HISTORIC AND DESIGN REVIEW COMMISSION

December 21, 2022

HDRC CASE NO: 2022-577
ADDRESS: 305 LAVACA ST
LEGAL DESCRIPTION: NCB 708 BLK 8 LOT 2 (305 LAVACA TOWNHOUSES)
ZONING: RM-4, H
CITY COUNCIL DIST.: 1
DISTRICT: Lavaca Historic District
APPLICANT: Tim Rodgers/South Flores Construction
OWNER: Tony Pearson/305 LAVACA TOWNHOUSES
TYPE OF WORK: New construction of two 2-story duplex structures
APPLICATION RECEIVED: December 05, 2022
60-DAY REVIEW: Not applicable due to City Council Emergency Orders
CASE MANAGER: Rachel Rettaliata

The applicant is requesting conceptual approval to construct two, 2-story duplex structures at 305 Lavaca.

③ REAR ELEVATION- NORTH
SCALE: 1/4" = 1'-0"

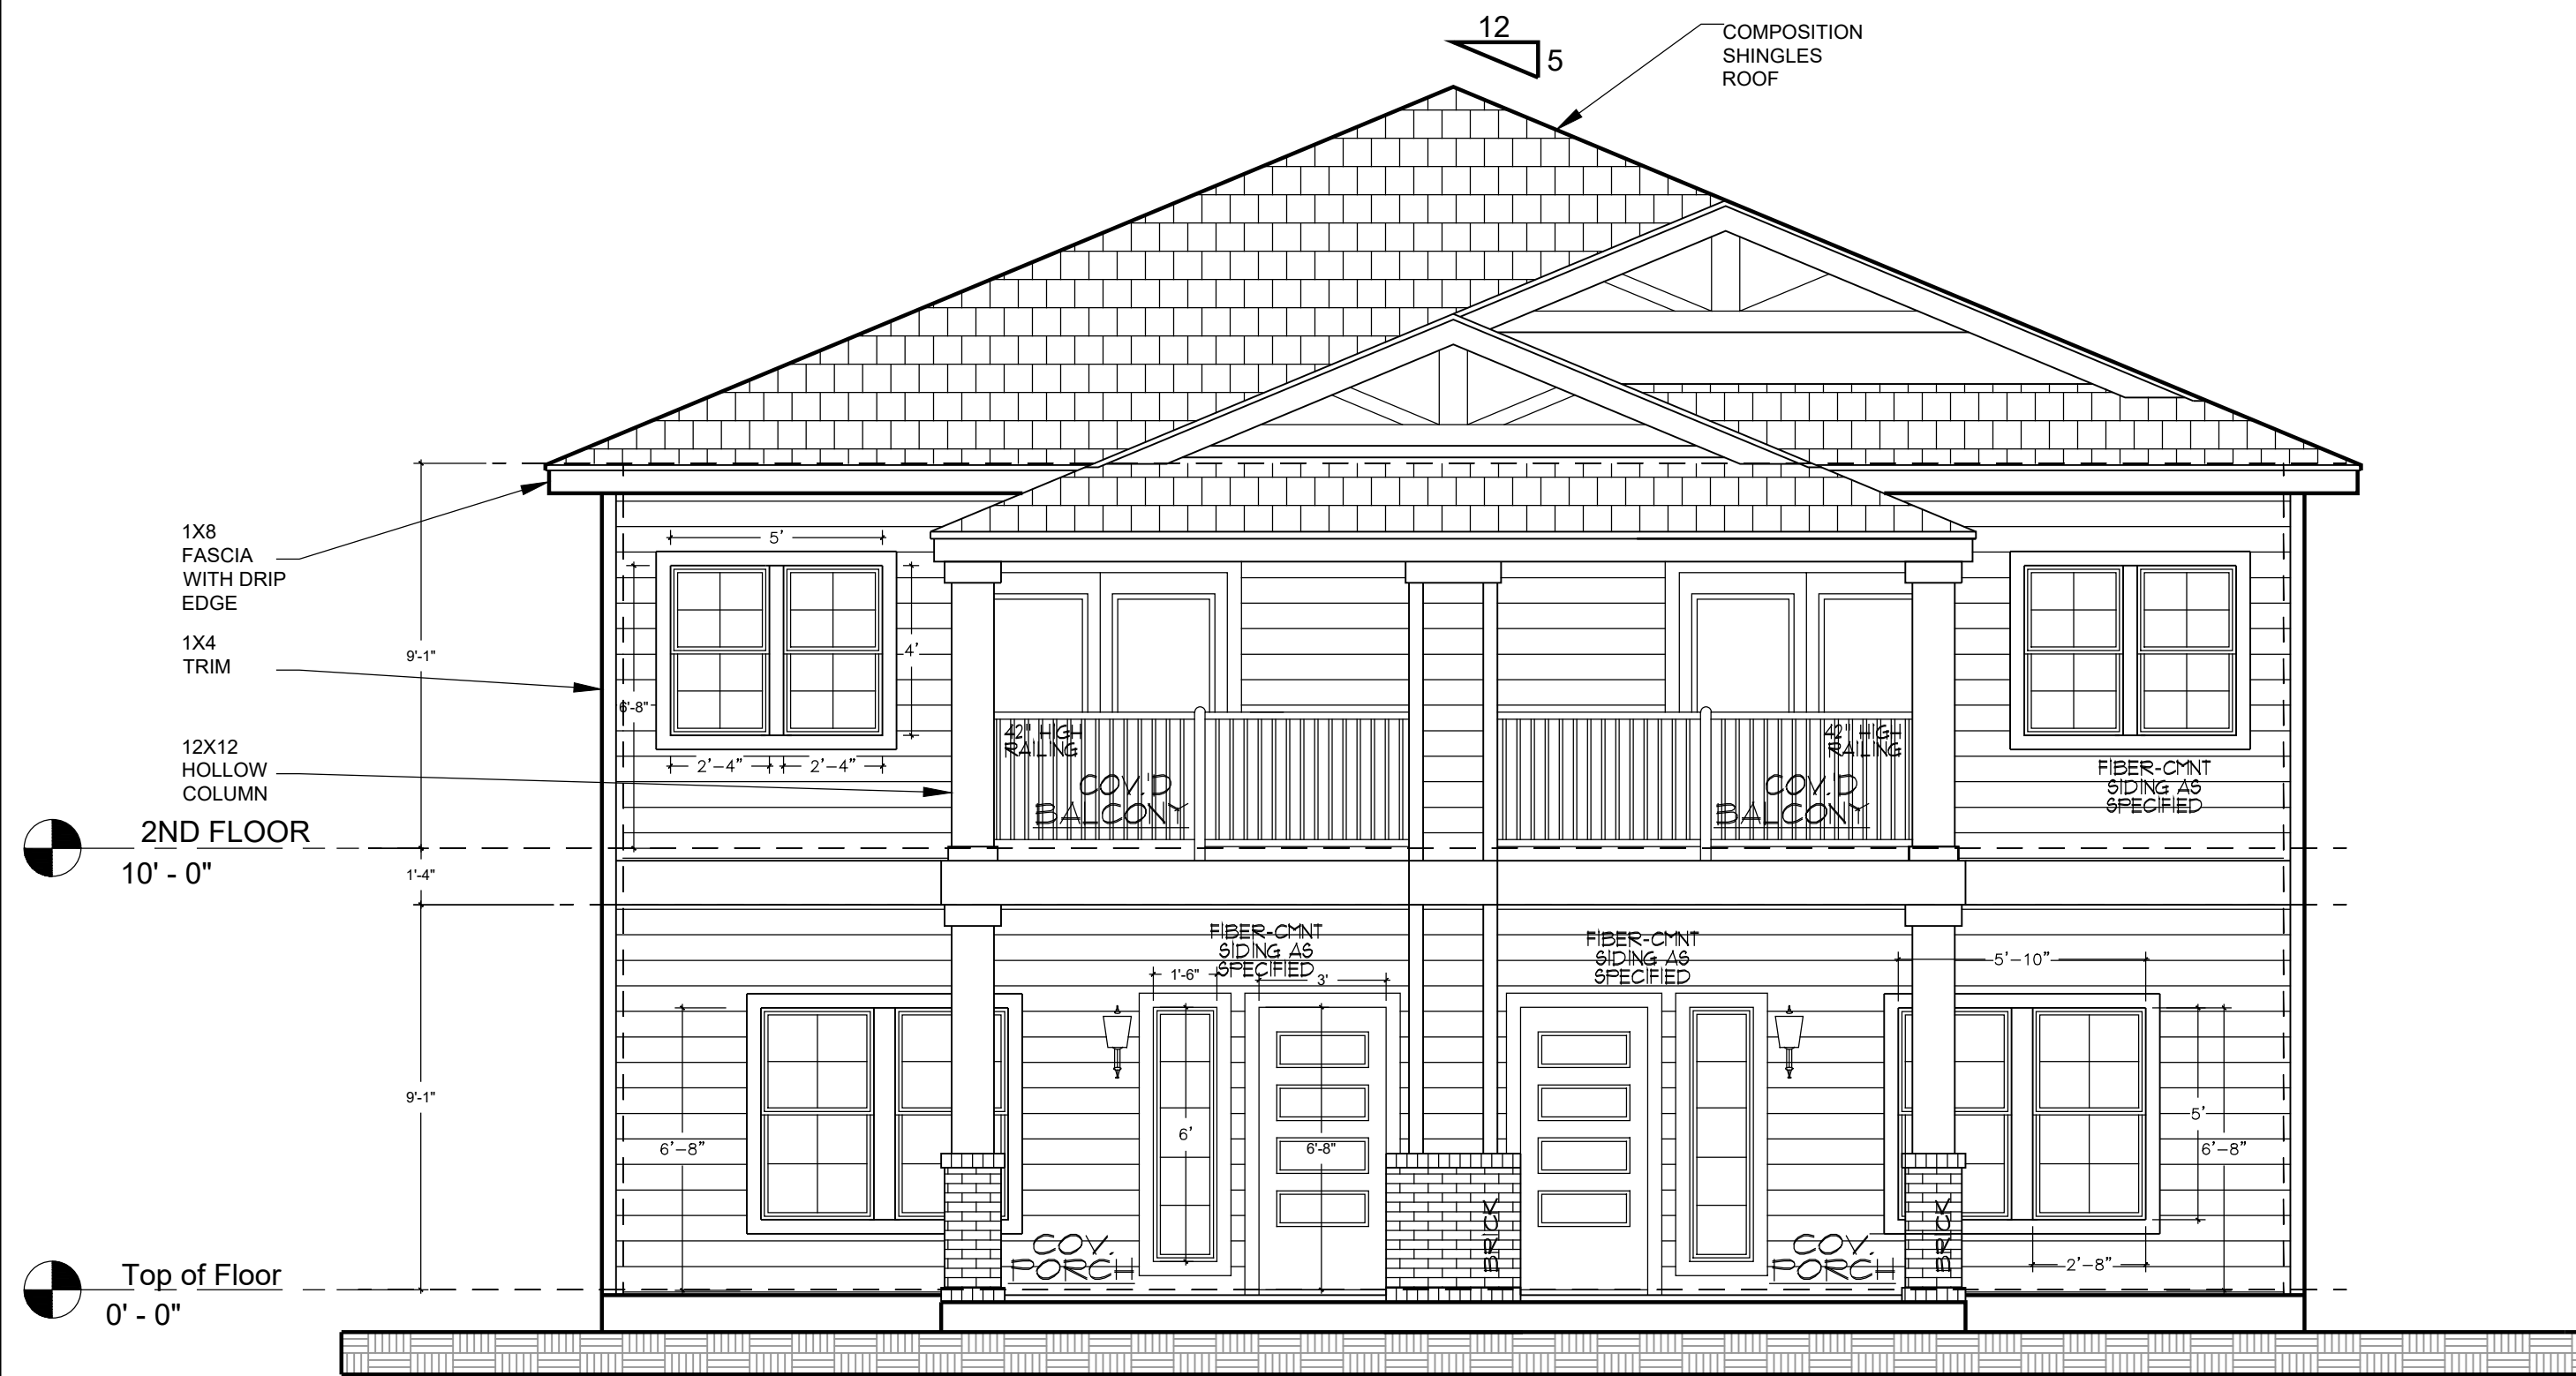
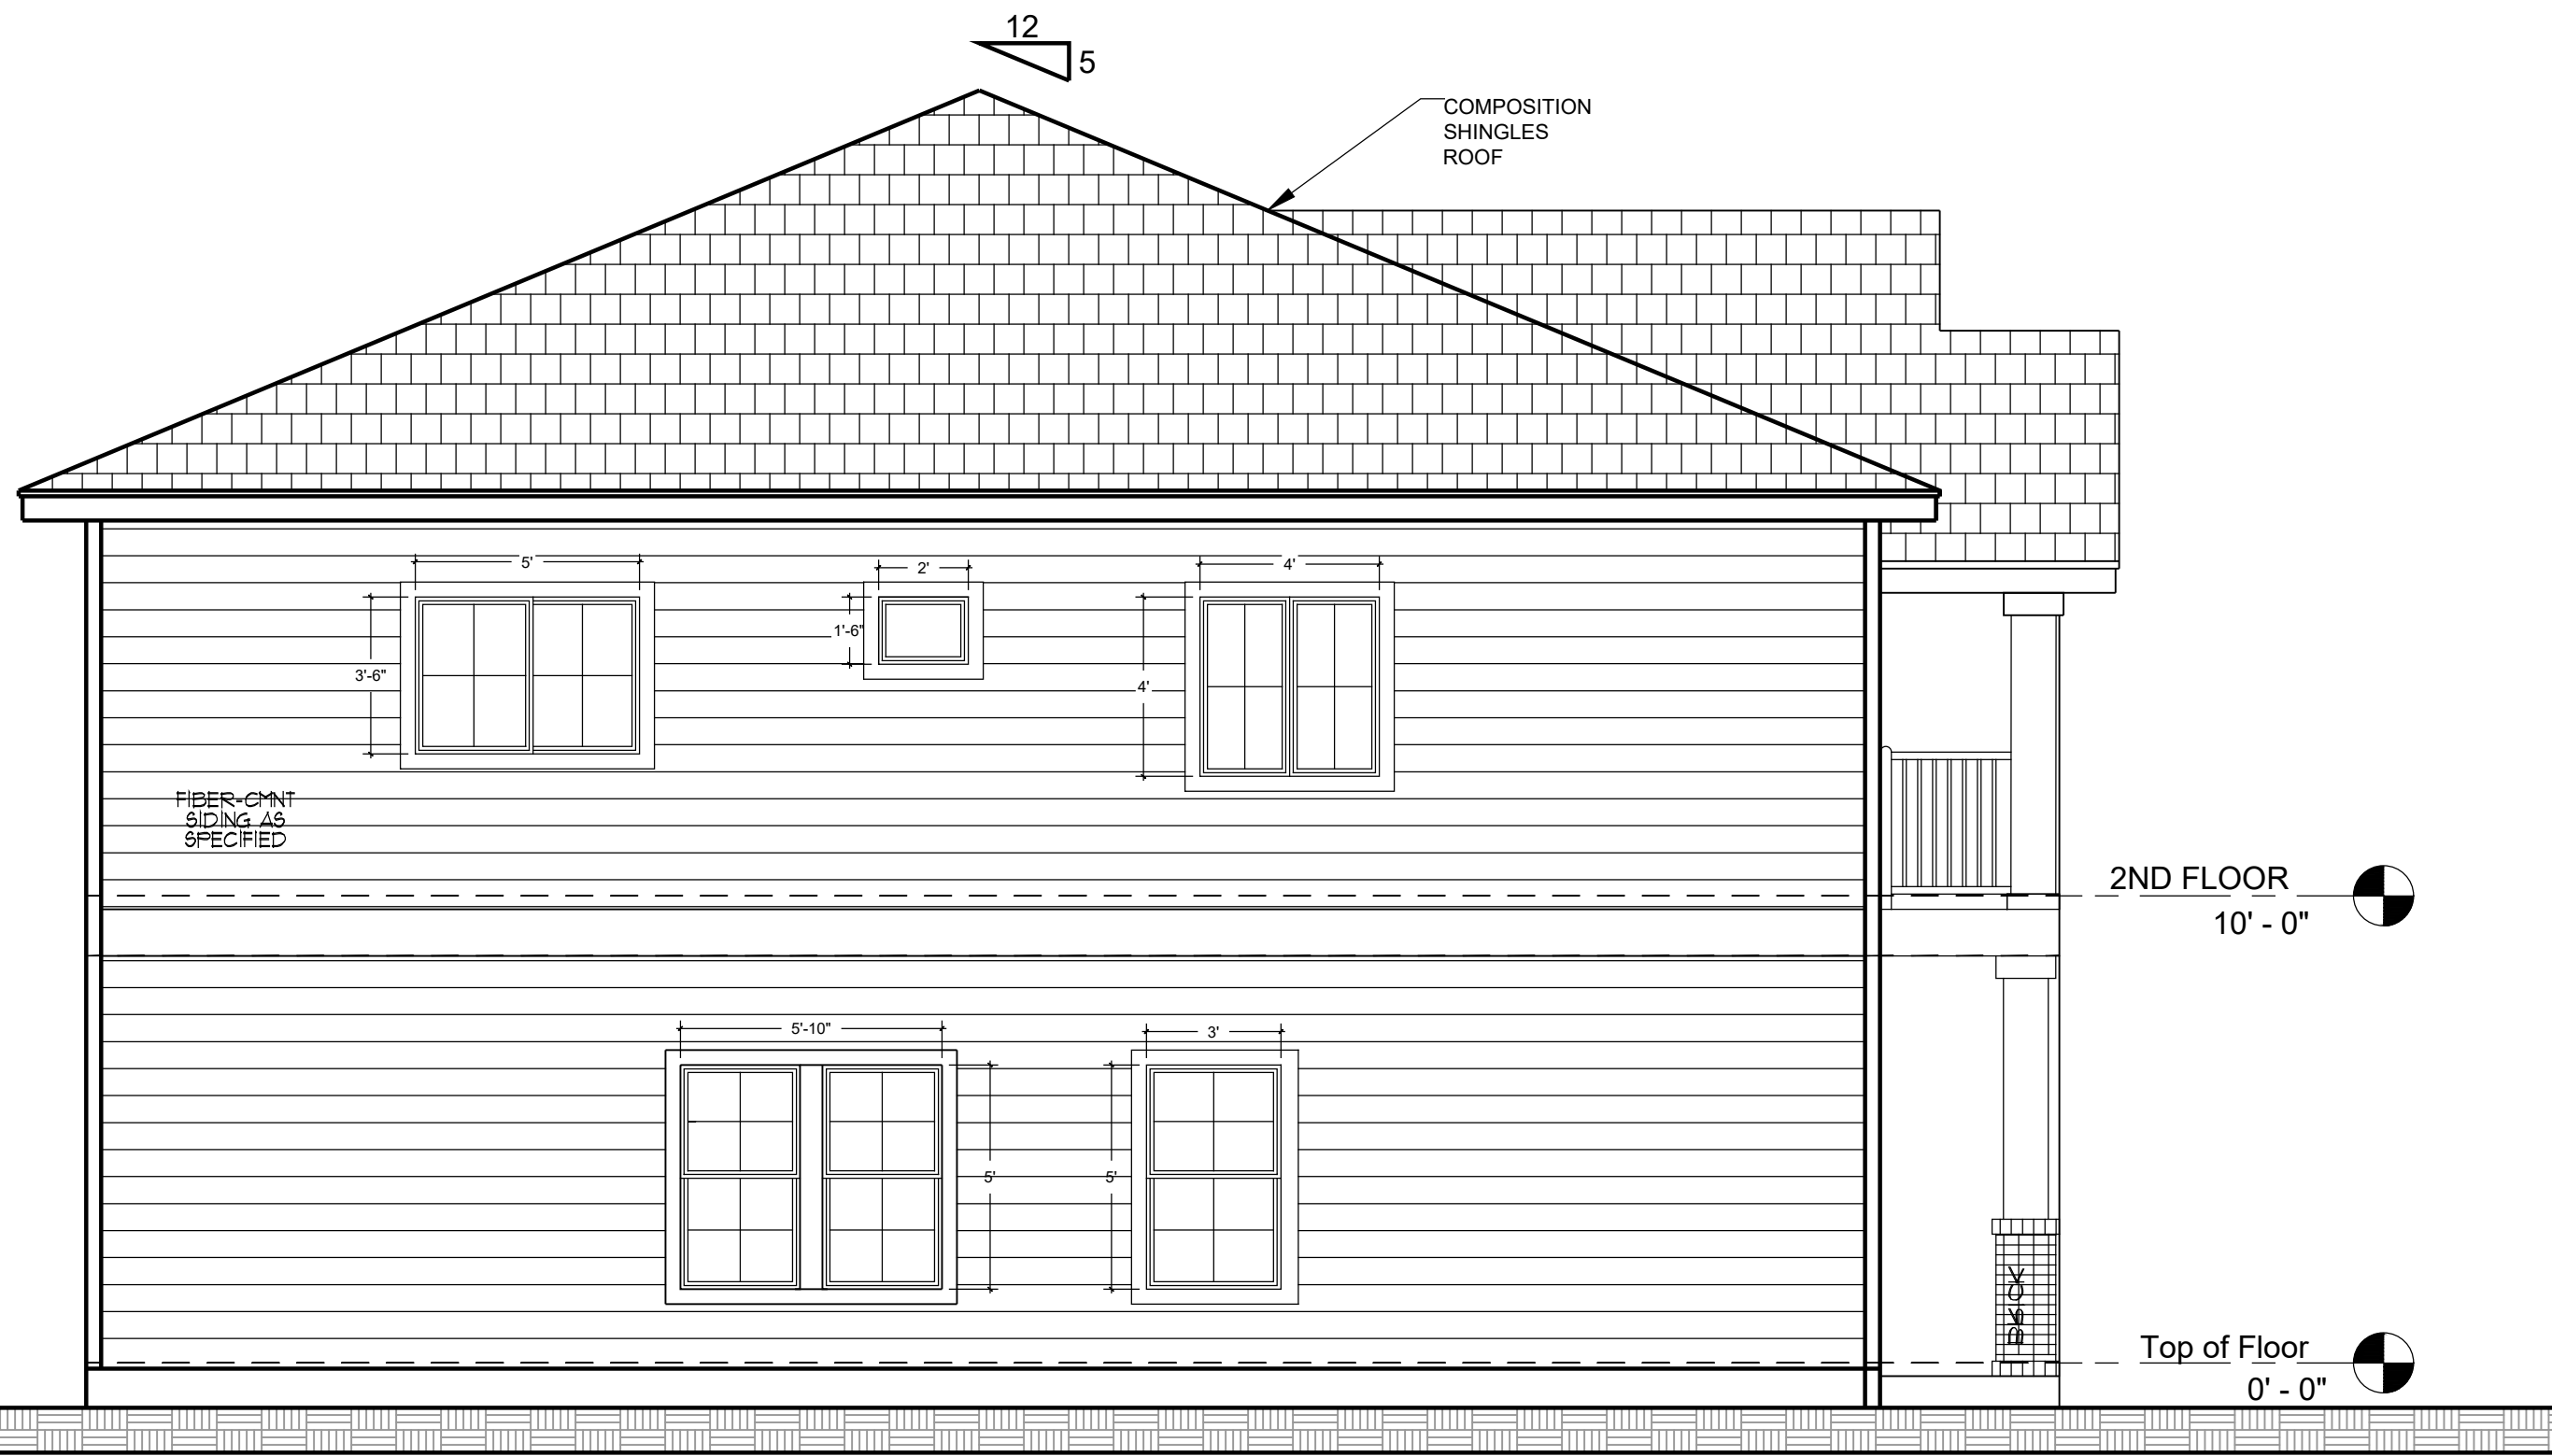
LG: I have a design question related to the front elevation and the brick base on the columns. The brick base is something that you may see on a Craftsman home and the columns are more Neo-Classical in style.
